ARLINGTON COUNTY, VIRGINIA

County Board Agenda Item
Meeting of May 14, 2022

SUBJECT: U-3468-16-1 USE PERMIT AMENDMENT for a below-grade parking structure with a lighted synthetic turf field above; located at 1601 Wilson Blvd.; (RPC# 16-032-001).

Figure 3: WRAP 18th Street North Section

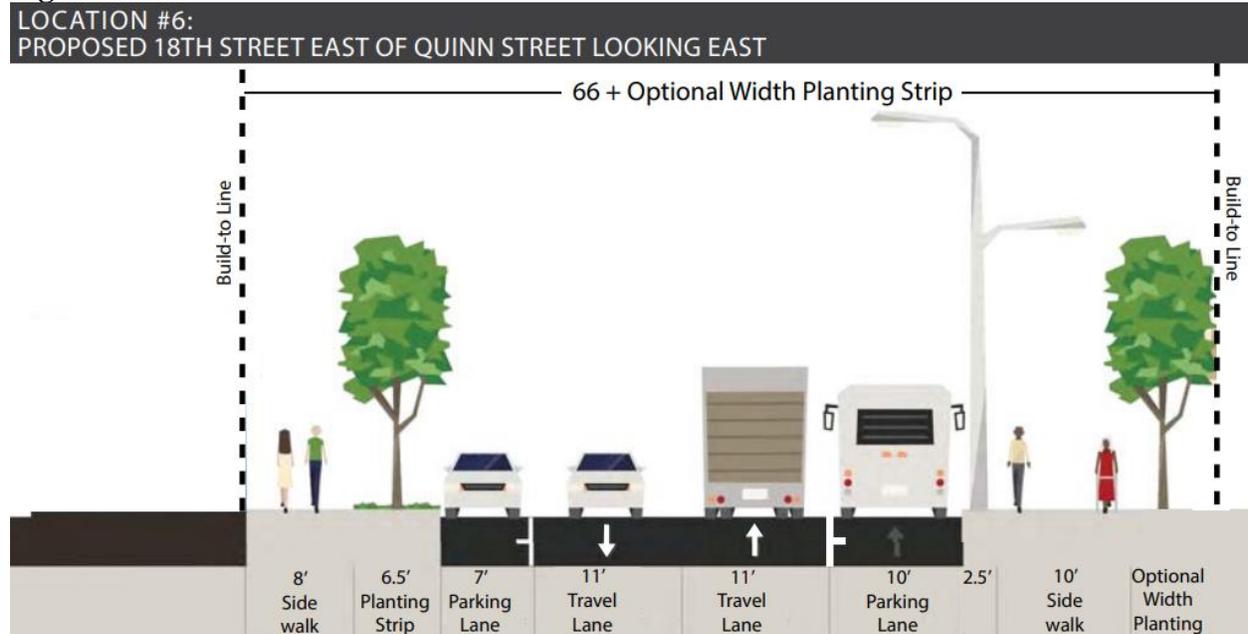
The applicant’s proposed 18th Street North segment is not consistent with the WRAP. The WRAP depicts a 39-foot-wide street to include an 11-foot travel lane in each direction, 7-feet of on-street parking on the north side of the street, and a 10-foot-wide bus parking lane along the south side of the street. The WRAP also depicts a 2.5-foot curb and lighting zone, a 10-foot-wide sidewalk, and an optional width for street trees along the back of sidewalk. The WRAP streetscape could support APS’s goal for a minimum 7-foot clear landing area by integrating street lighting with the poles used for field lighting at the back of sidewalk on the garage structure.

The County does not support the proposed narrowing of 18th Street North because it does not comply with the WRAP recommendations, and it could cause significant operational issues along the street, impacting APS proposed bus operations without otherwise prohibiting parking on the north side of the street. To prohibit parking on the north side of the street twice a day or more would limit the street’s public use to an extent not previously planned or contemplated. This will be discussed in more detail below as part of the discussion section. Staff recommends updating the APS proposal to be generally consistent with the WRAP streetscape and street cross section.

As stated above, removing the parking lane is not consistent with the WRAP recommendations and raises operational concerns. If the parking lane along the south side of 18th Street North is to remain, the resulting streetscape width from the curb to the face of the parking structure would be 15 feet 3 inches which could include a 13-foot 3-inch combined boarding/alighting zone and clear sidewalk with a 2-foot-wide planter strip and seating along the parking structure wall. Street trees would not be able to be accommodated due to the space needed for bus operations including boarding, alighting, queueing, and circulation. This streetscape along APS frontage would support APS operational needs without narrowing 18th Street North.

Figure 4: WRAP North Quinn Street Section

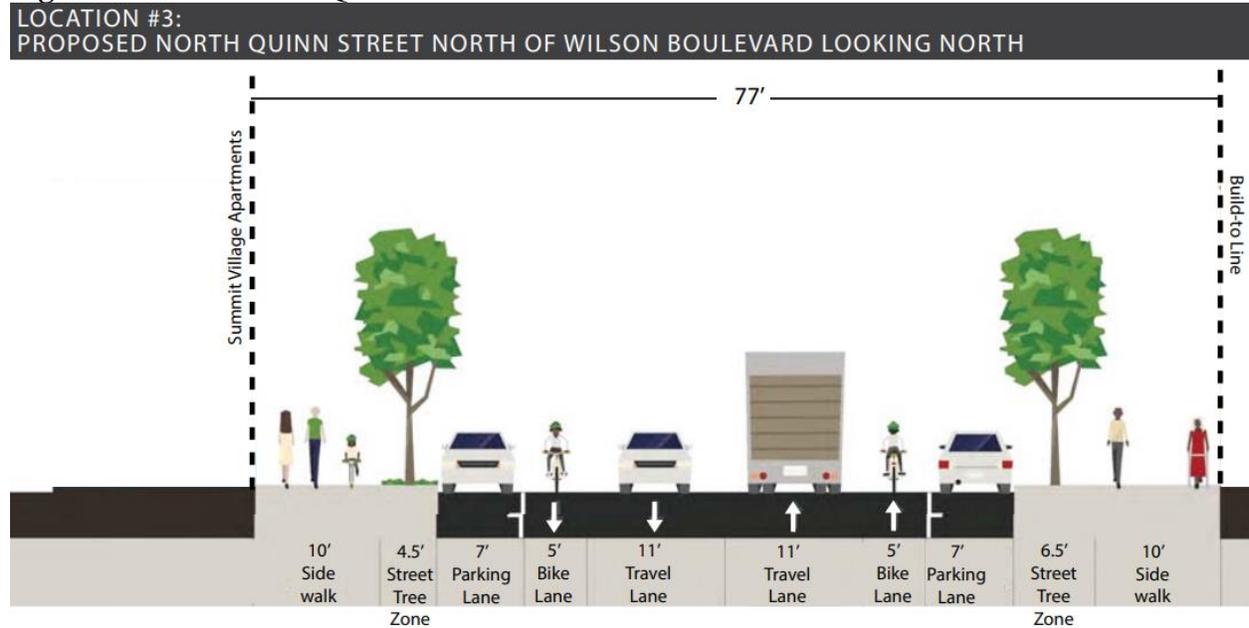
North Quinn Street– The proposed North Quinn Street segment is generally consistent with the WRAP. Overall, the 46-foot-wide street includes an 11-foot travel lane in each direction along with 7-feet of on-street parking and 5-foot bike lanes on both sides of the street. The sidewalk along North Quinn Street is proposed to be a minimum of 15 feet wide. This streetscape includes a 5-foot-wide street tree and furniture zone and a 10-foot clear sidewalk.

Following the construction of Phase 1 of the Heights, new ADA parking spaces were constructed along North Quinn Street to support operations at the school and the broader community. Those 3 spaces were reconstructed to be wider than the typical 7-foot parking lane. The additional width was achieved by removing the street trees in that area thus narrowing the streetscape. These wide ADA spaces allow vehicles to deploy an ADA lift for either side of the vehicle or the rear of the vehicle. With construction of Phase 2 of the Heights, staff recommends APS consider moving these spaces north along the North Quinn Street frontage such that they are closer to the proposed Shriver entrance. This can be accomplished administratively after County Board approval with approval of the final civil engineering plans.

Figure 5: Phase 2 Proposed Site Circulation and Access

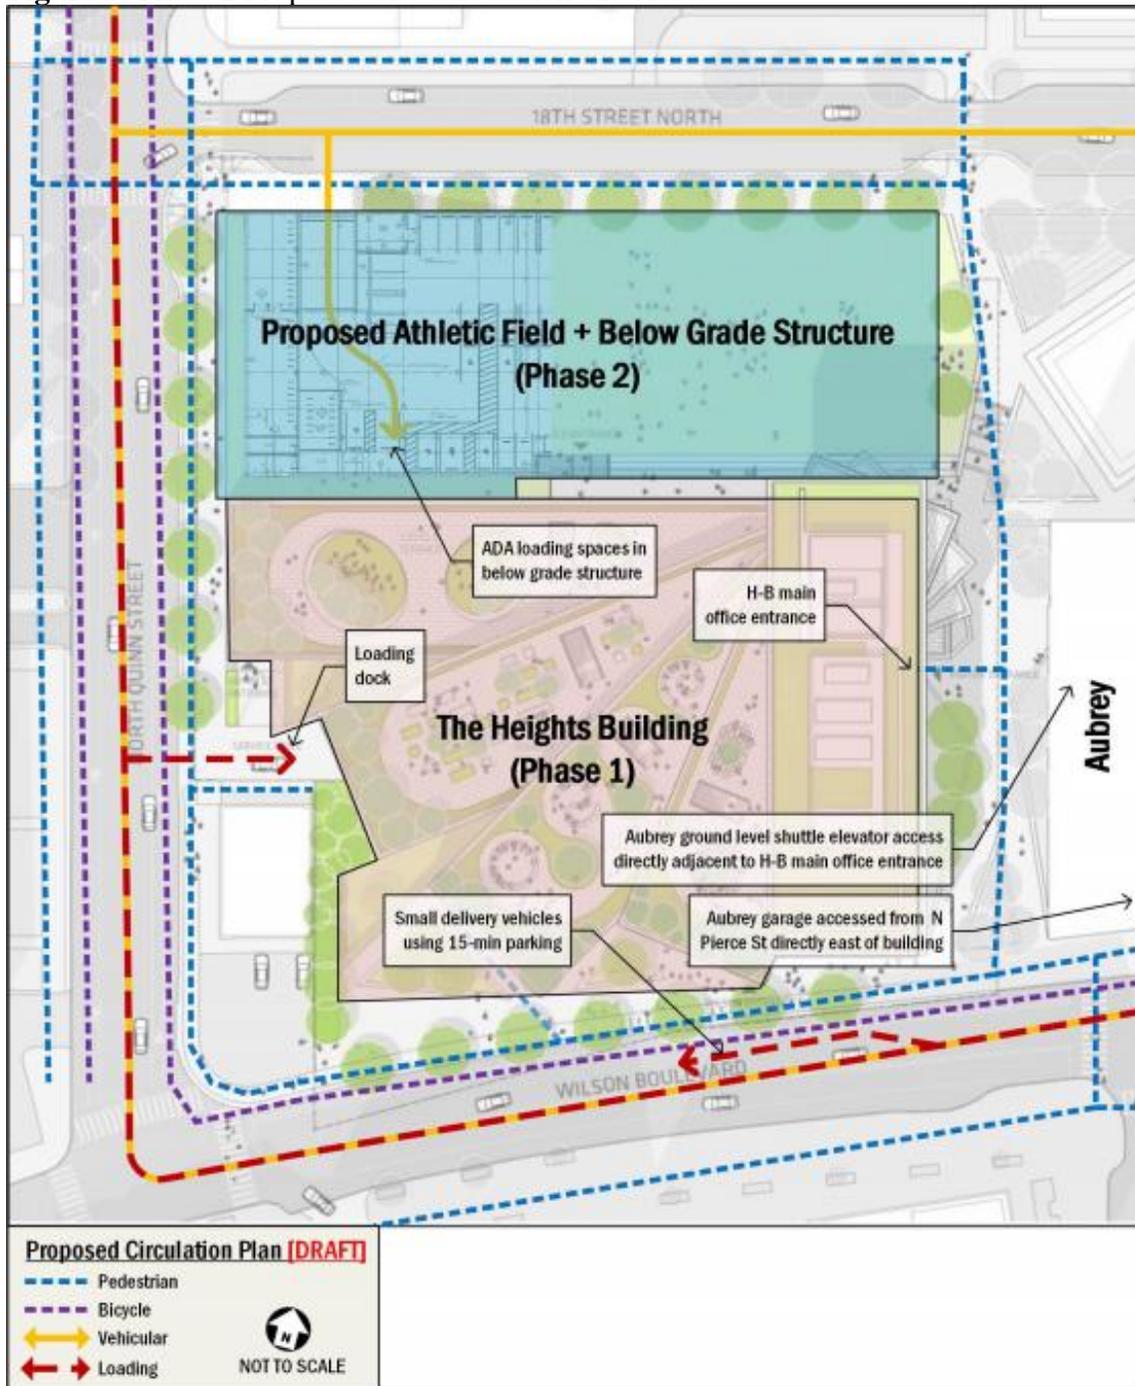
Garage Access – APS has proposed garage access from 18th Street North. This proposed access point would be within the portion of 18th Street North that APS anticipates closing during arrival and dismissal. During this period APS proposes limiting access to the garage to ADA PUDO activities only. The proposed garage access poses a significant operational and safety challenge that APS will have to manage during arrival and departure periods. Arlington County Police and Arlington County Department of Environmental Services do not currently have surplus resources available to manage the closure of 18th Street North twice a day throughout the school year. During the closure of the street, for APS operations, APS will be solely responsible for the safe movement of buses, vehicles, and students within this space. A new condition could require APS to get approval for and implement an operations and safety plan for 18th Street North closures.

18th Street North Operations: By locating the proposed garage entrance along 18th Street, APS has created a conflict between bus operations and vehicles entering and exiting the garage making closure of 18th Street during arrival and departure more complicated. During periods when the street is closed to non-APS traffic, school staff will be responsible for safely directing and managing traffic. Neither Arlington County Police nor Arlington's Department of Environmental Services currently have surplus staffing resources available to support the closure of the street twice daily by APS.

Staff recommends that APS be required to develop a comprehensive operations and safety plan for the closing of 18th Street. The plan should not only demonstrate what type of traffic control will be used (signs, barriers, staffing etc.) but also the staffing and training that will be provided by APS to ensure the safety of students, staff, and the general public. Staff recommends that the County Manager review and approve APS's plan prior to APS being permitted to close the street for exclusive use during arrival and dismissal periods. The operations of the street closure and the associated management and direction of traffic represents a significant safety obligation
